Village of Cassopolis

CWSRF Interceptor Force Main Replacement

ADDENDUM 1

June 12, 2026

Sheet SR-6.7-8 – Peavine Street Surface Restoration Plans Sta. 35+00 to 45+00

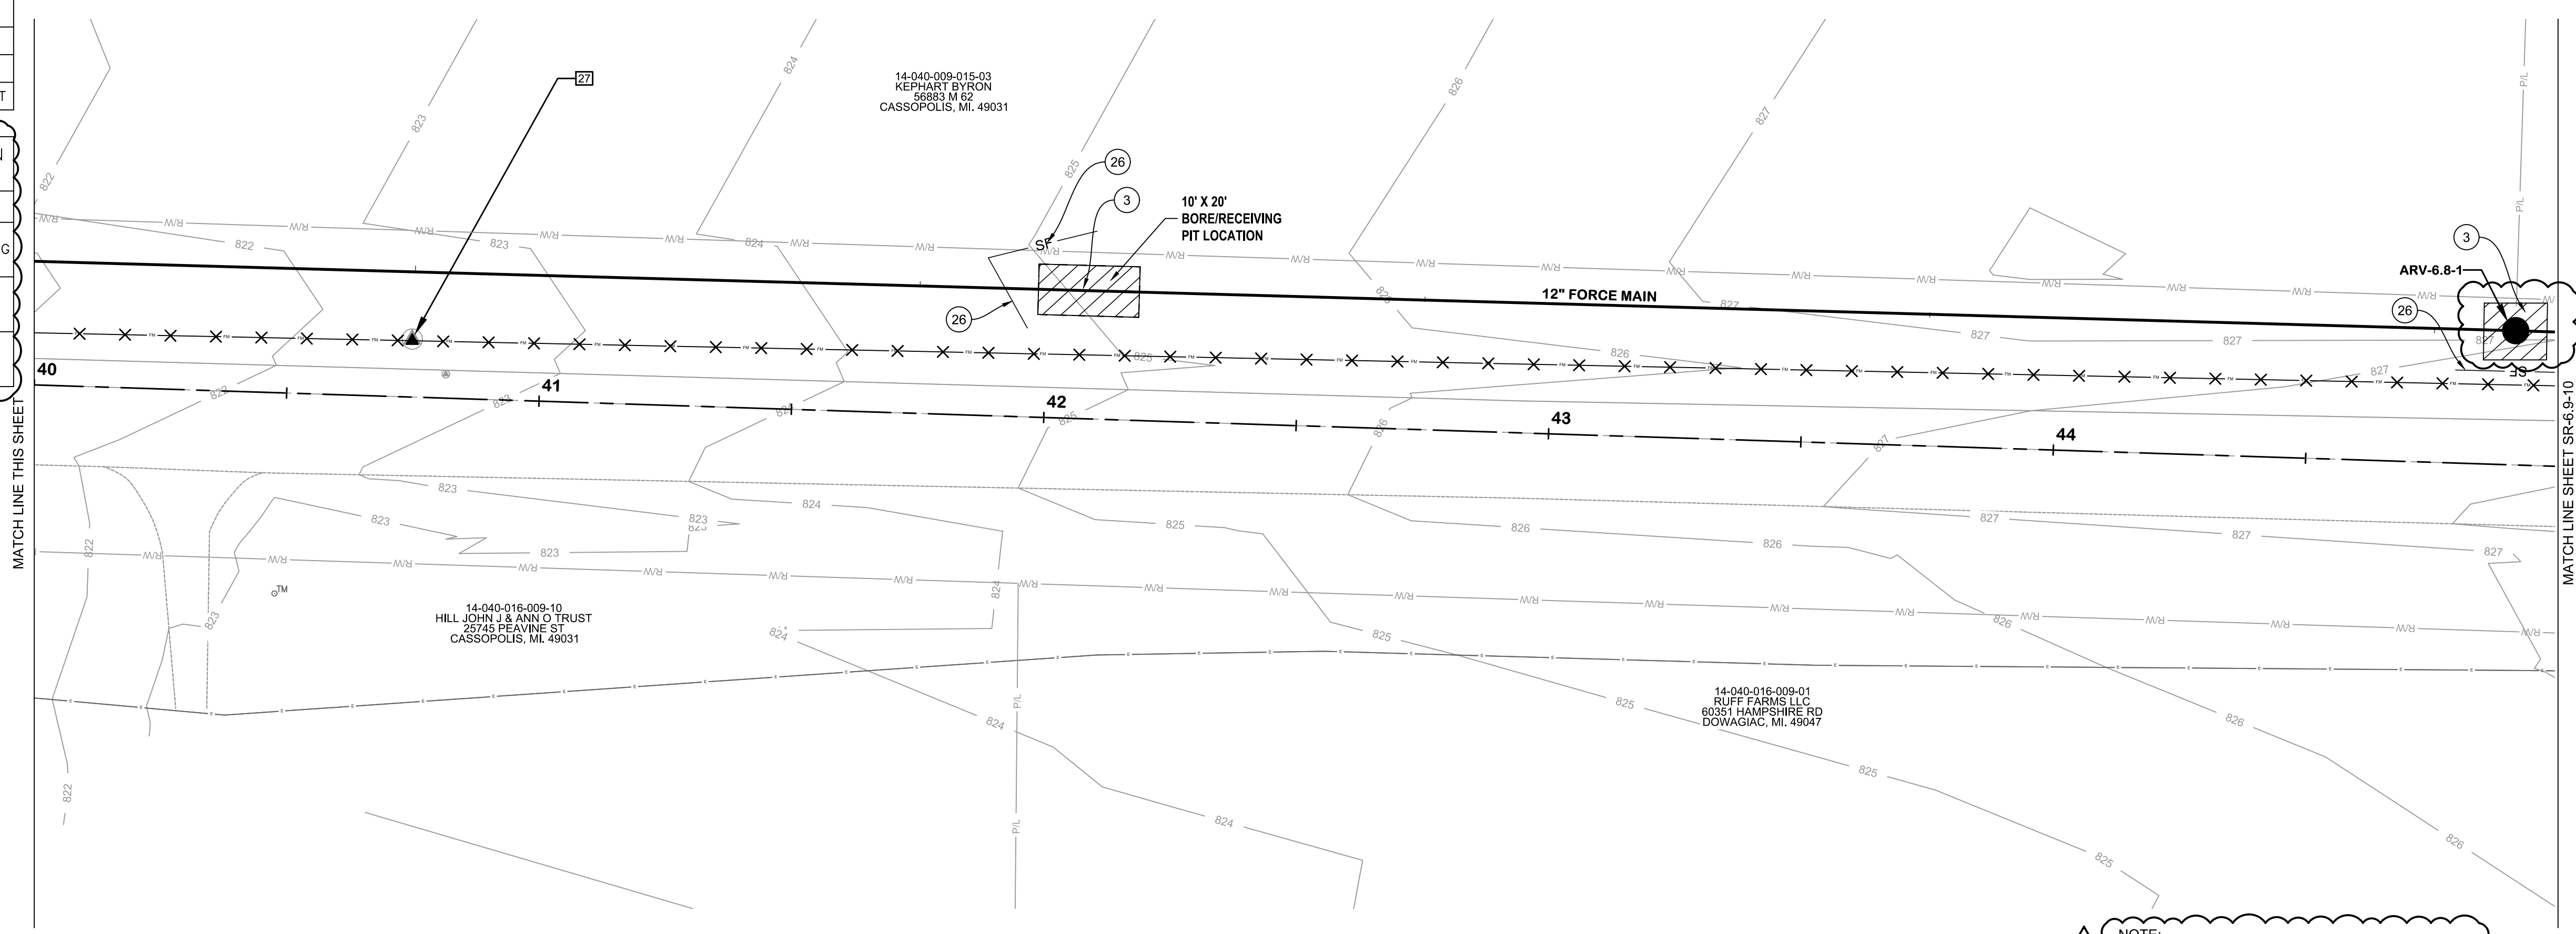
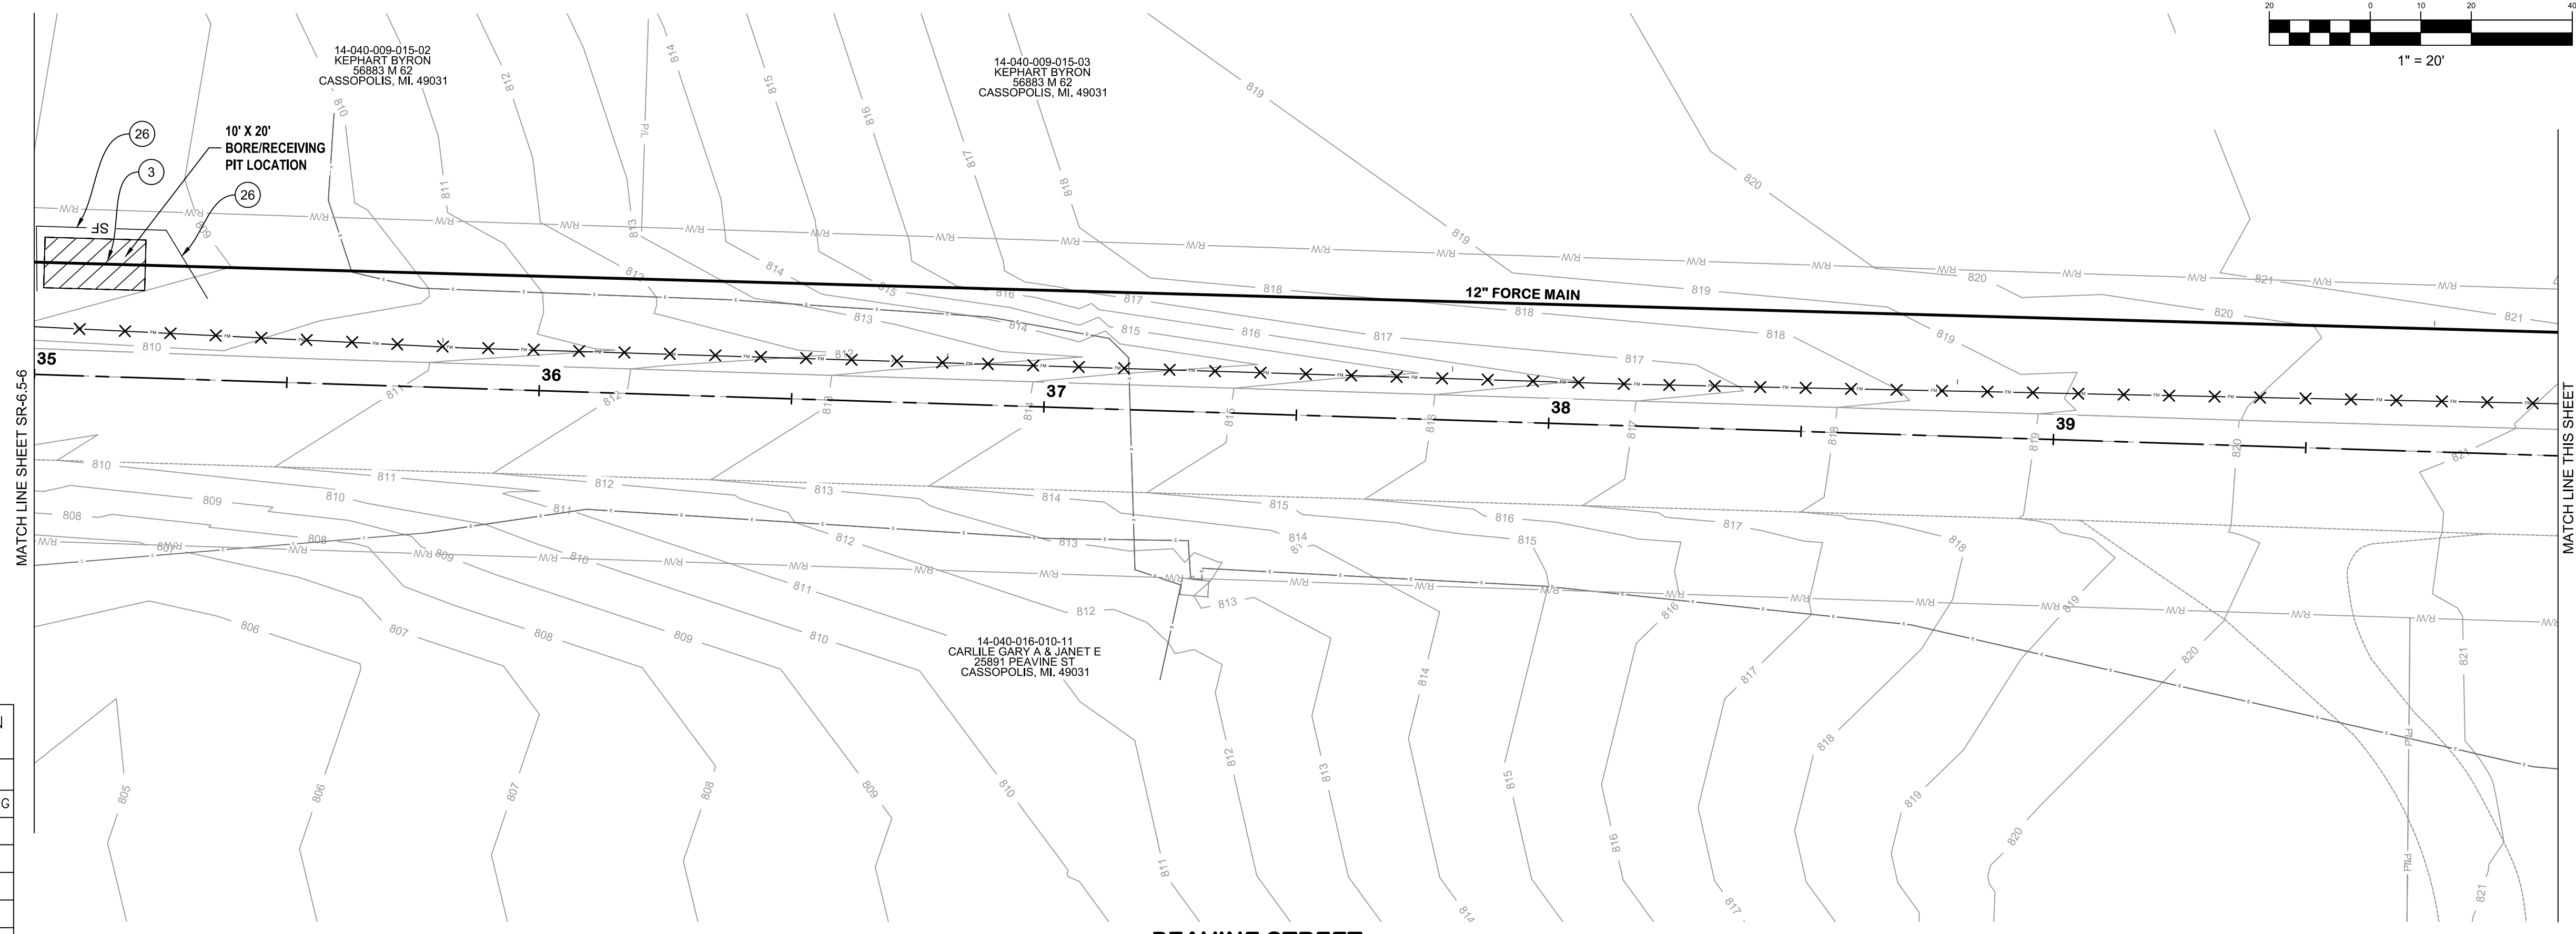
The ARV symbol was modified on this sheet. Replace the sheet with the provided Sheet SR-6.7-8 included with Addendum 1.

NOTE:
1. THE ARV SYMBOL WAS MODIFIED ON THIS SHEET. ALSO SURFACE RESTORATION HATCH LEGEND. REPLACE THE SHEET WITH THE PROVIDED SR-6.7-8 INCLUDED WITH ADDENDUM 1.

Sheet SR-6.11-12 – Peavine Street Surface Restoration Plans Sta. 55+00 to 65+00

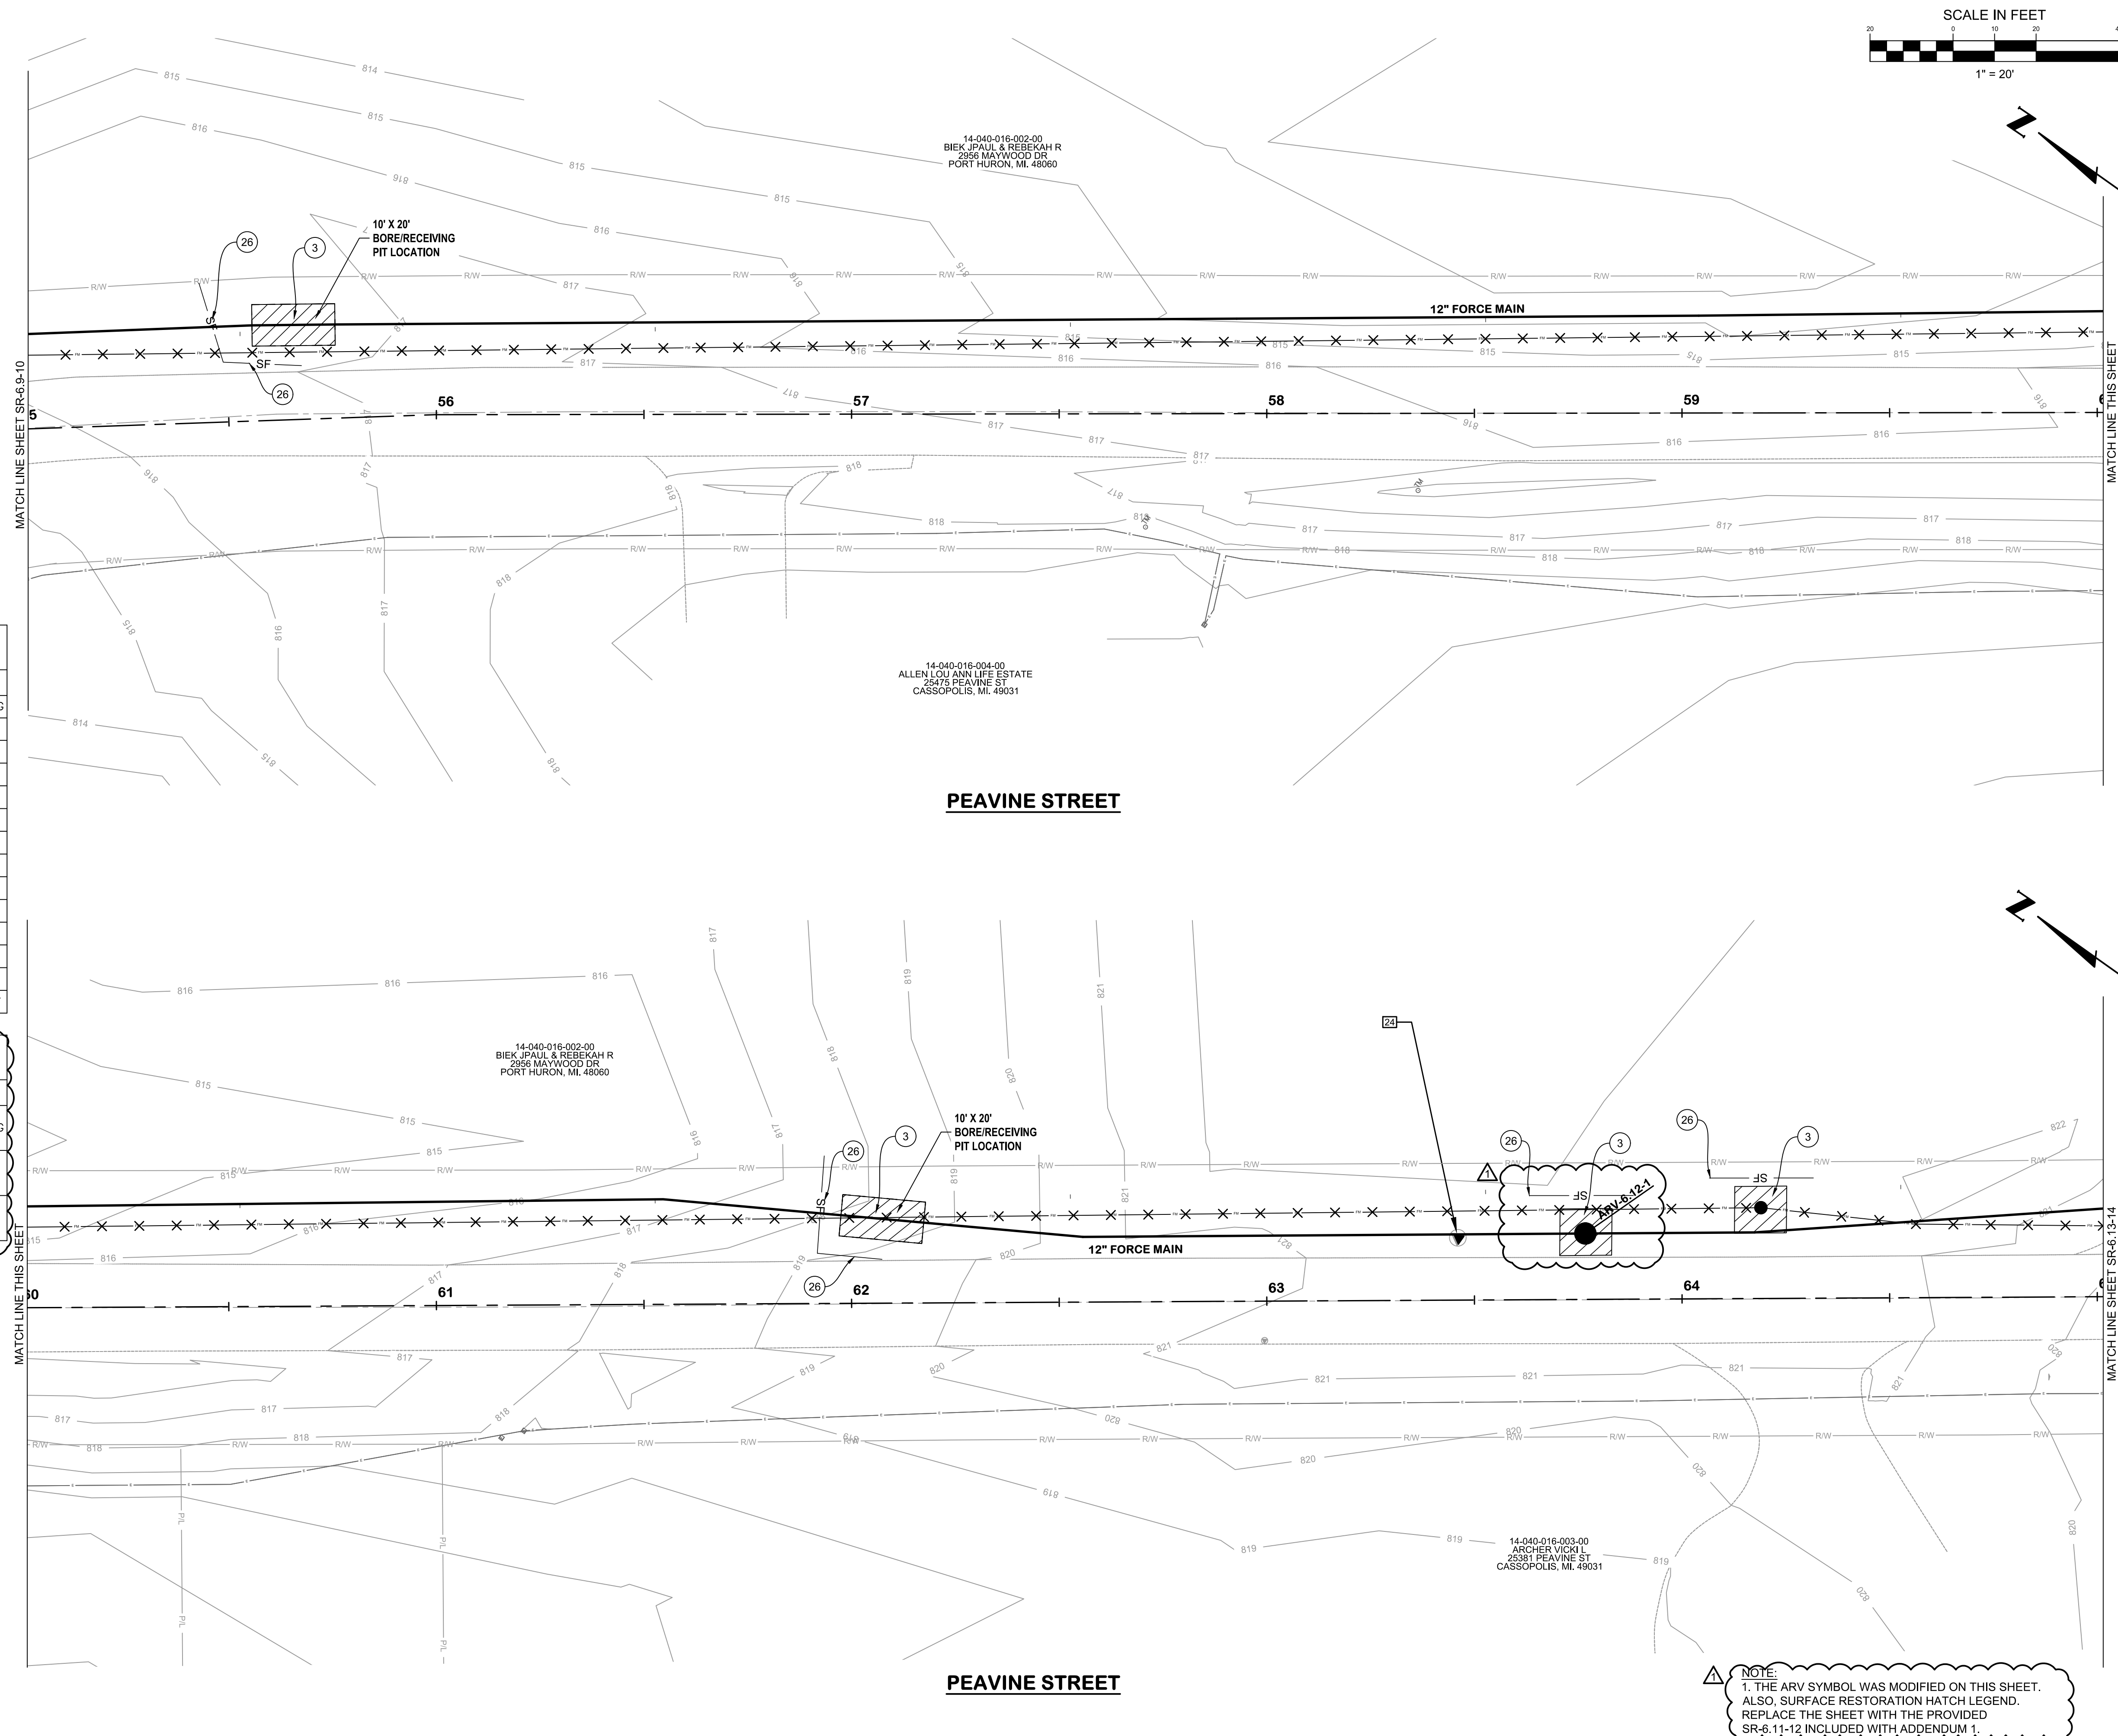
The ARV symbol was modified on this sheet. Replace the sheet with the provided Sheet SR-6.11-12 included with Addendum 1.

NOTE:
1. THE ARV SYMBOL WAS MODIFIED ON THIS SHEET.
ALSO, SURFACE RESTORATION HATCH LEGEND.
REPLACE THE SHEET WITH THE PROVIDED
SR-6.11-12 INCLUDED WITH ADDENDUM 1.
